Permit Number: 080088

has permission to New 3 story above grade college of Pharmacy teaching research & Administrative Office Facility on Stevens Ave

From: Mike Nugent [mailto:mjn@portlandmaine.gov]
Sent: Sunday, February 24, 2008 2:17 PM
To: jsb@alliedcook.com ; lita@portcityarch.com
Cc: Gregory Cass; Jeanie Bourke; Lannie Dobson
Subject: UNE College of Pharmacy Permit # 080088 CBL 145 E003

1ST FLOOR

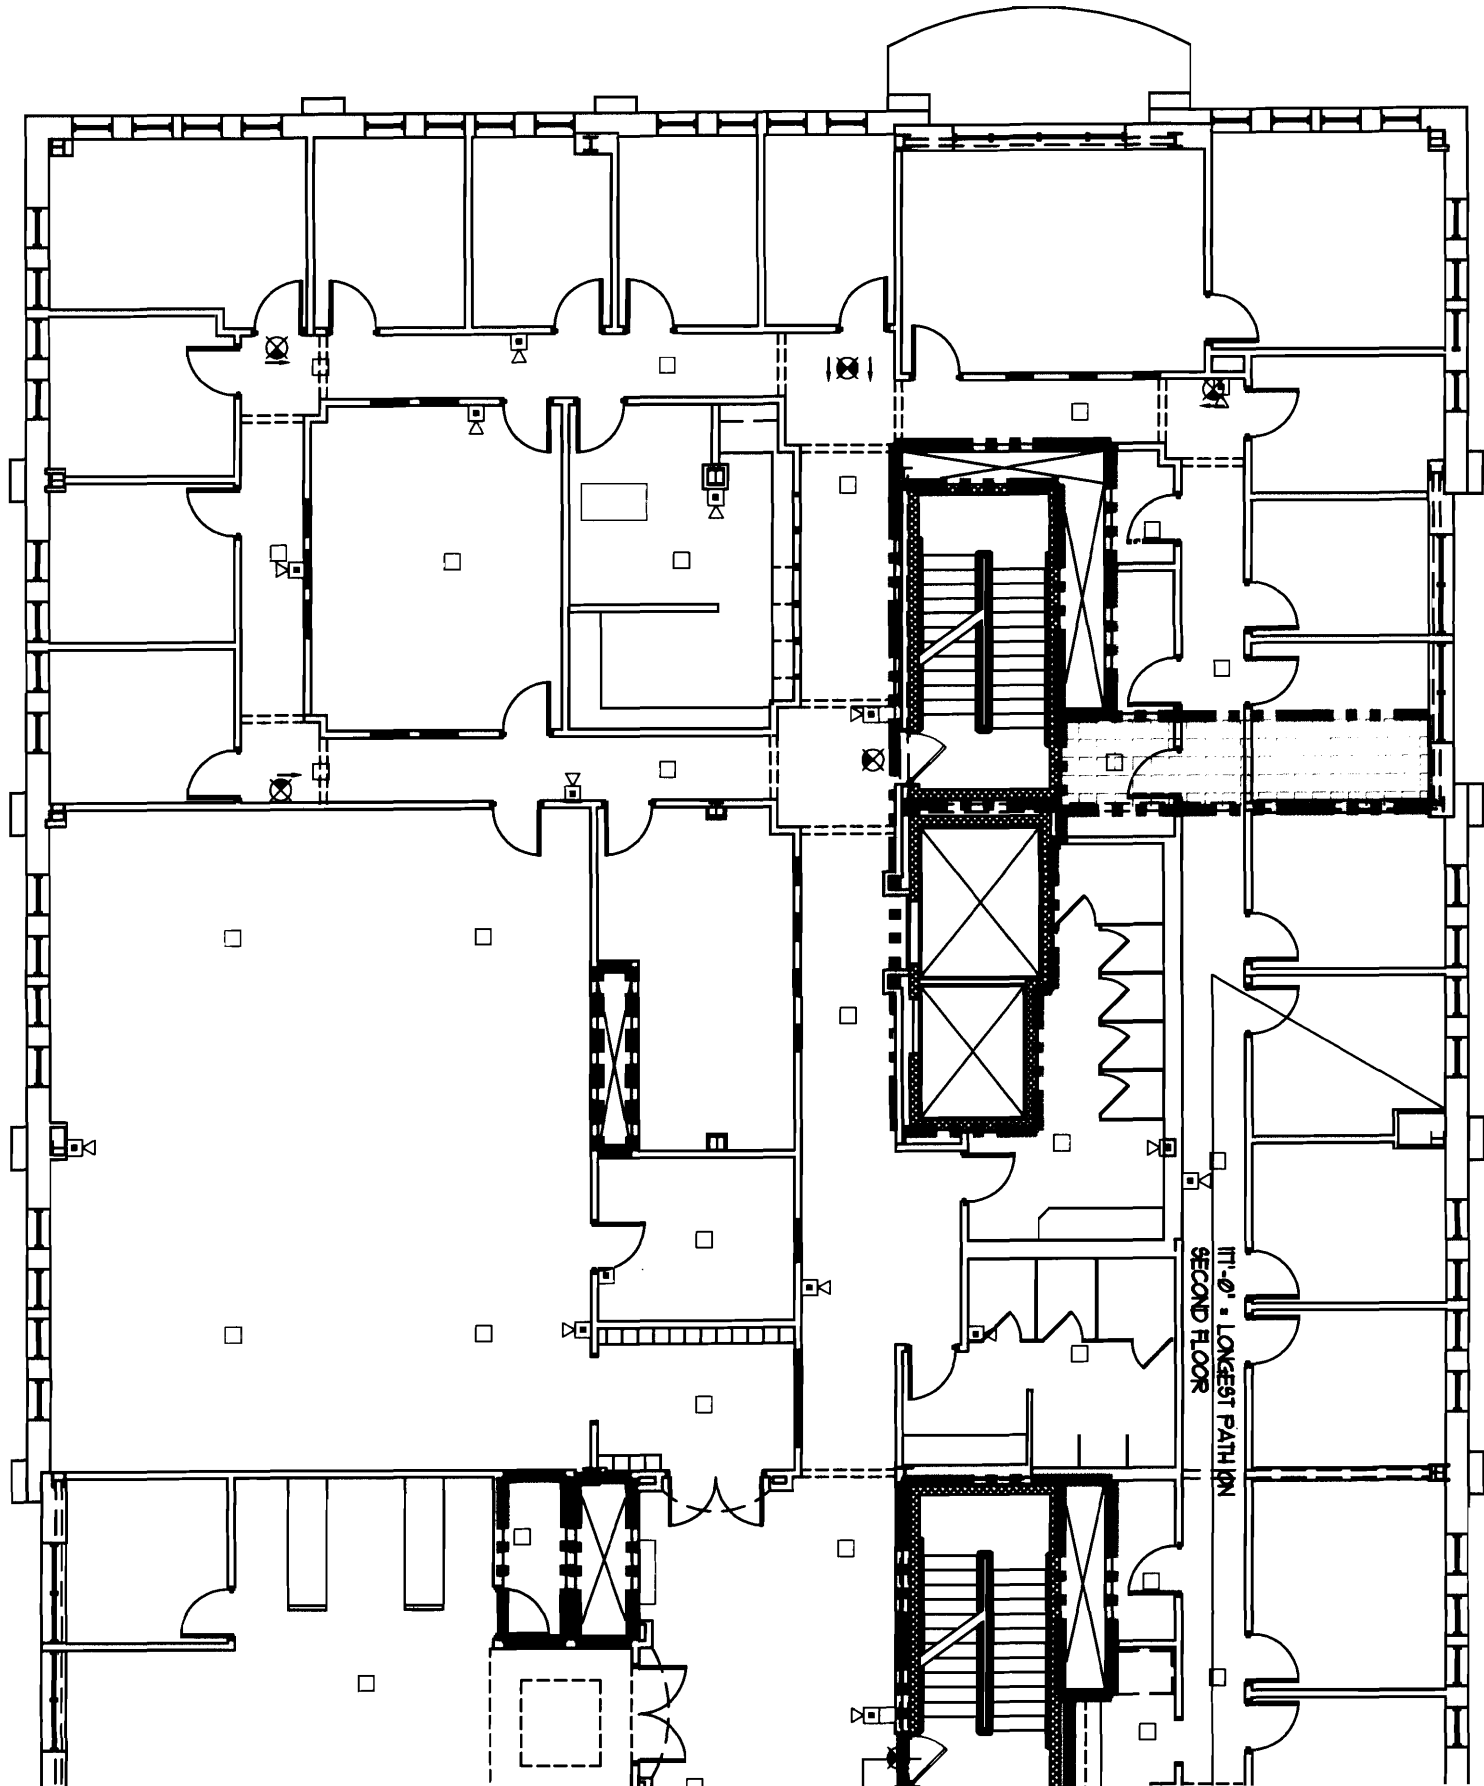
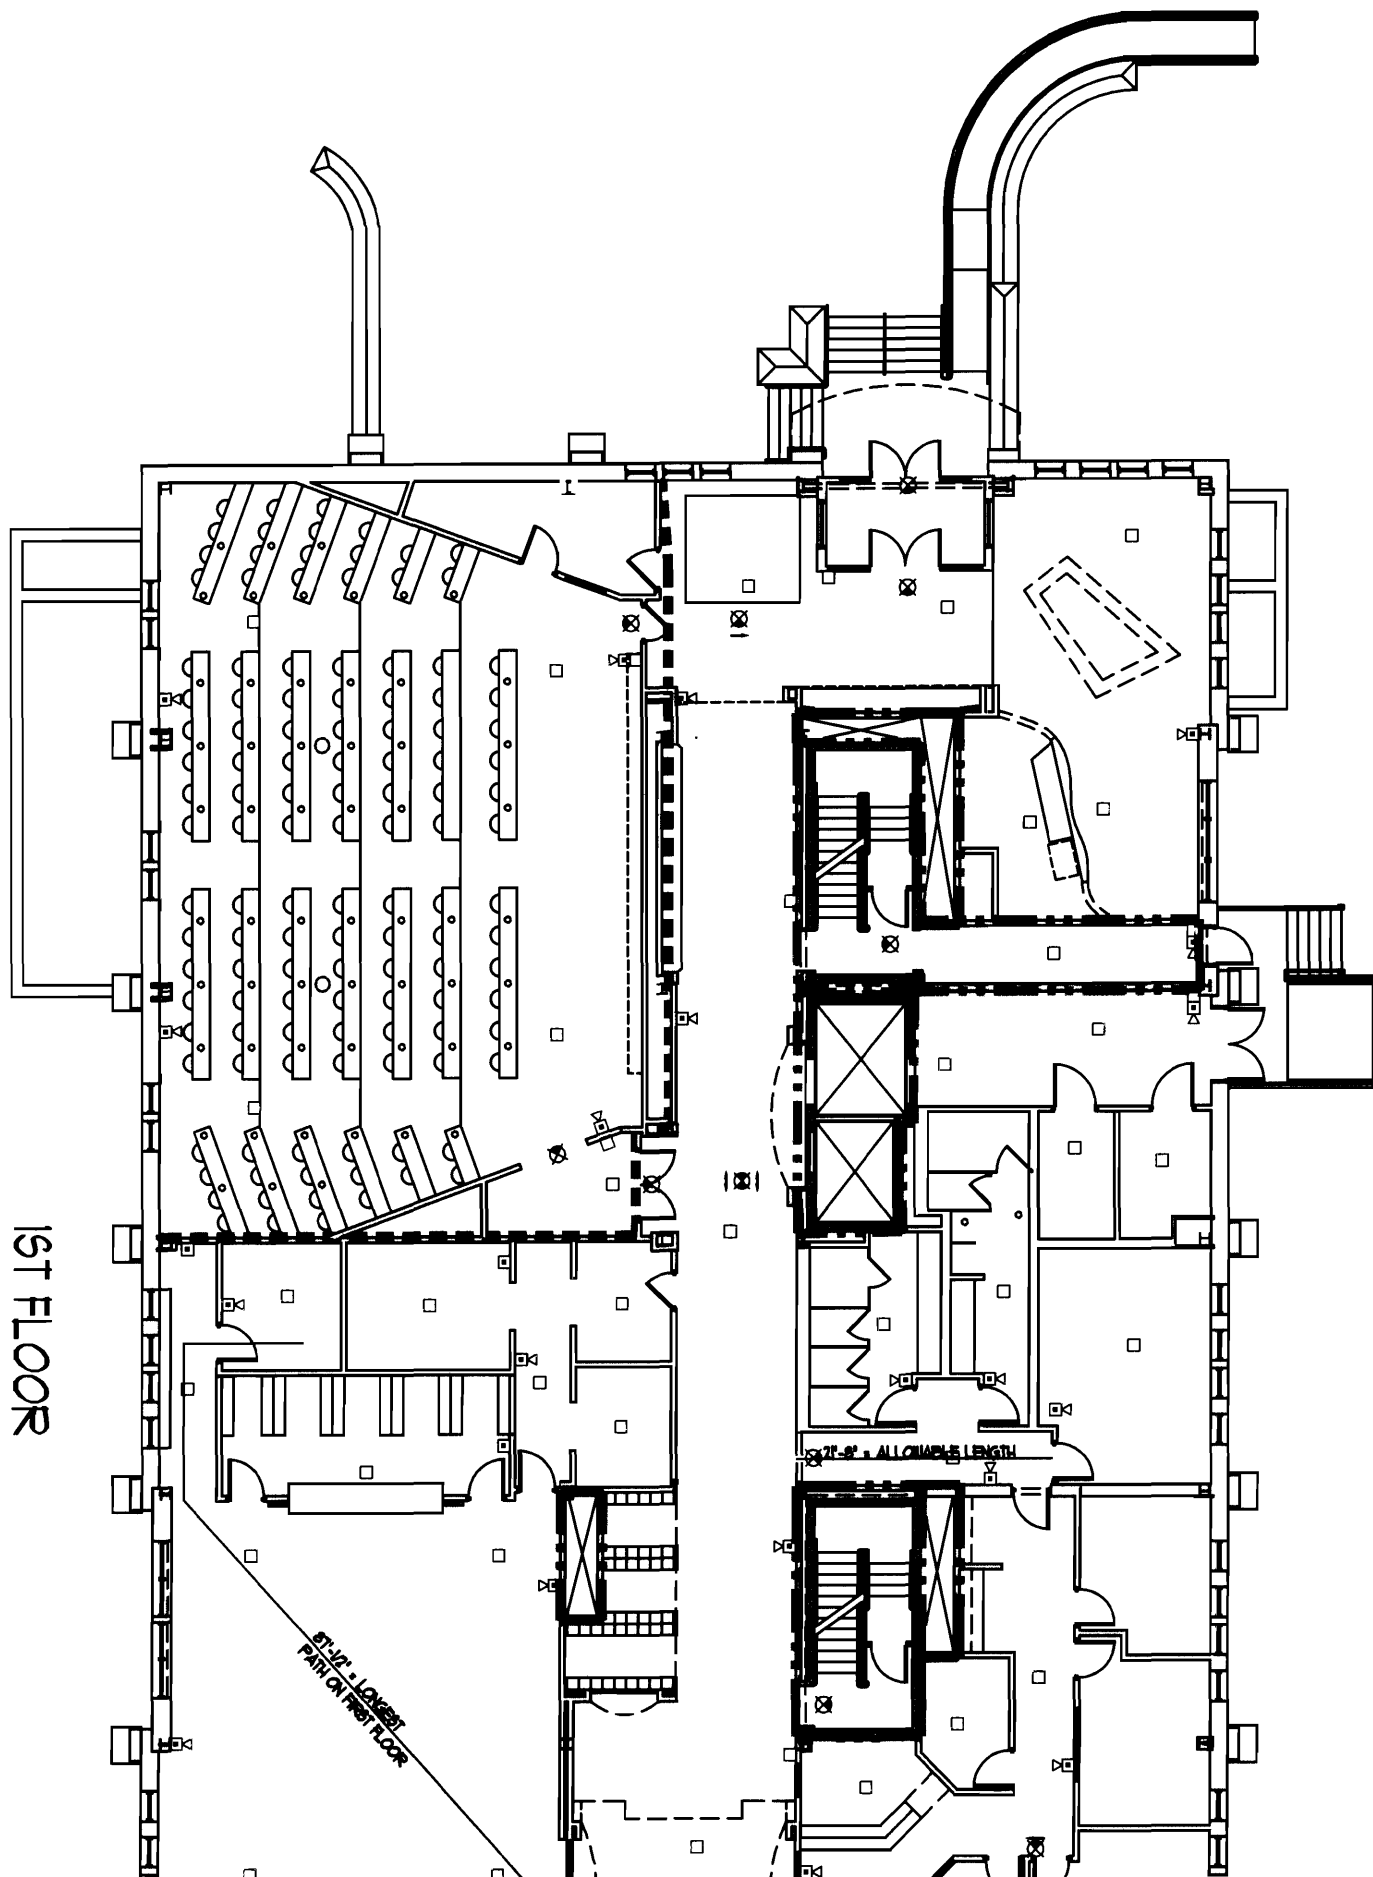
- 4) There is a large Assembly room (A-3) on the first floor that is not separated from the adjoining "B" use, Please provide a code justification for this omission, there are also no fire dampers shown on M1.2 for the penetrations to this area.

- We caught this in our last review - do you have the latest set (came out last week) - it is also included on a new code review page which we will include a copy when we drop off the spec (and this drawing is included in the new set) . . . I will also check with Mechanical . . .
